# CANYON LAKE HYPOLIMNETIC OXYGENATION SYSTEM PRELIMINARY DESIGN PHASE I REPORT

**Addendum #1**

**Date:** March 30, 2011  
**To:** Rick Whetsel, SAWPA Senior Watershed Planner  
**From:** Andy Komor, MS, PE  
**Re:** **Preliminary Response to HOS Comments** # 9653E

### PACE RESPONSE TO COMMENTS

Figure 21: Submerged Speece Cone Conceptual Flow Schematic

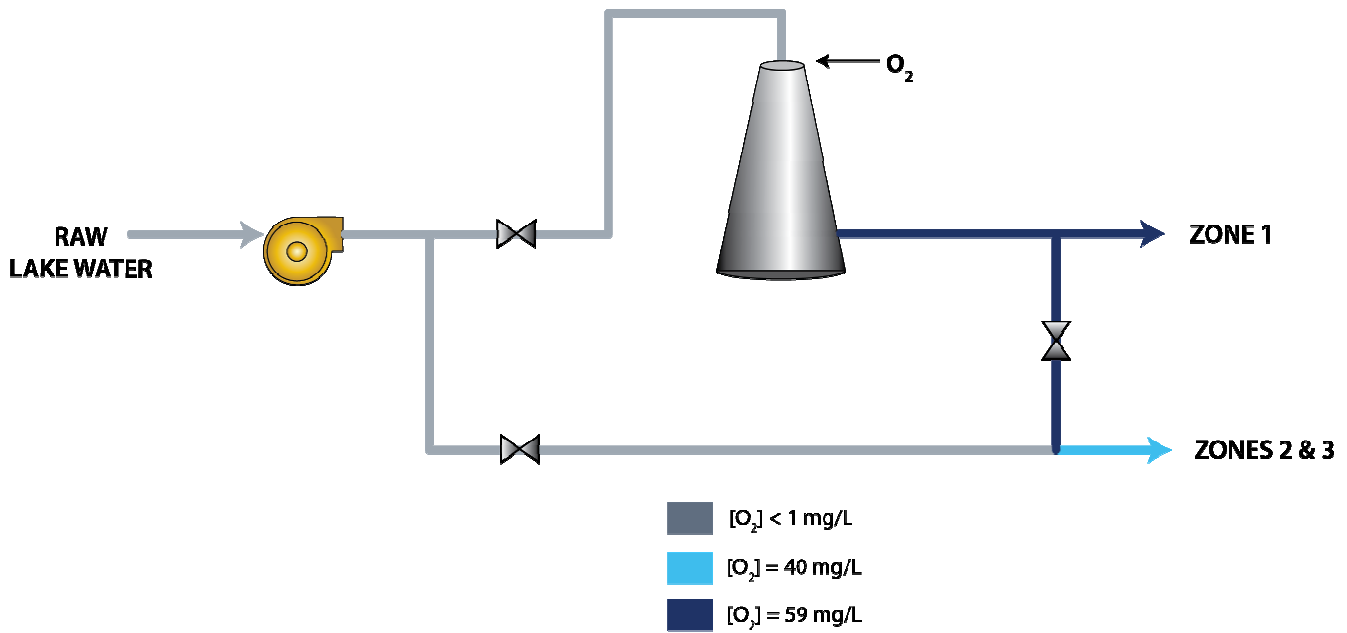
Does the term "modified side-stream" mean that the output of the BlueinGreen system is mixed with non-oxygenated lake water by a mixing valve system as shown in fig 21 on page 5-27 to produce a lower oxygen concentration ? If so, how are these valves controlled: automatically or by the operator ? If automatically, what does that control system look like, if by operator, how does he know where to position the valves ?

To clarify, the modified side-stream includes mixing of the two water sources described. The mixing is achieved using a carefully designed orifice nozzle which controls the discharge of high oxygen water from the oxygenation equipment into the large pipe containing lower oxygen water. The nozzle shall be sized by the manufacturer, and verified by the engineer, to achieve proper back pressure for optimal oxygenation equipment operation. The nozzle is not adjustable.

**Figure 25: Canyon Lake Proposed Equipment Locations**

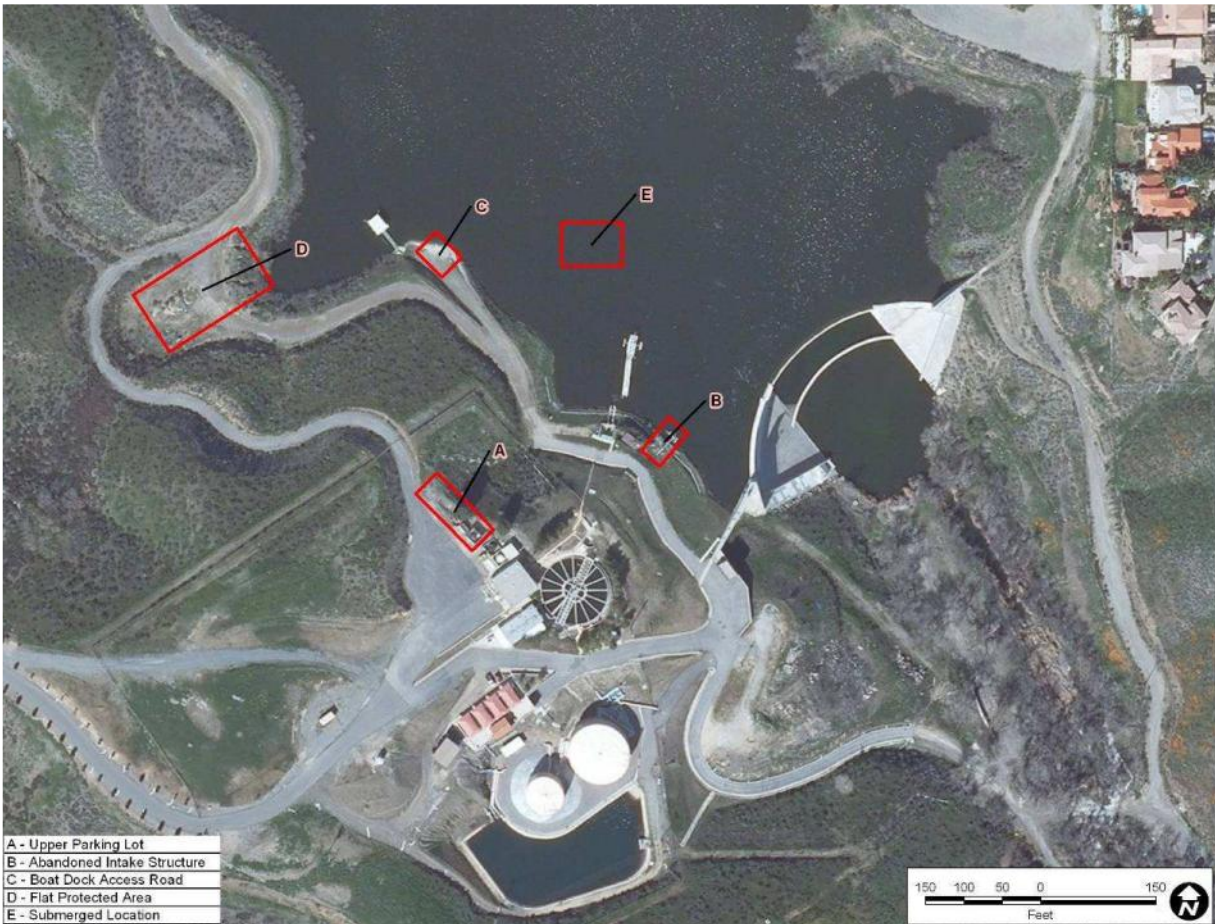
15. Page E-4, define WTP, LOX & EVMWD. Provide a reference as to where locations A, B & C are (i.e. see fig 25, page 5-33).

- 31. Page 5-33, 1<sup>st</sup> para, 2<sup>nd</sup> sentence, replace Figure 252 with Figure 25.
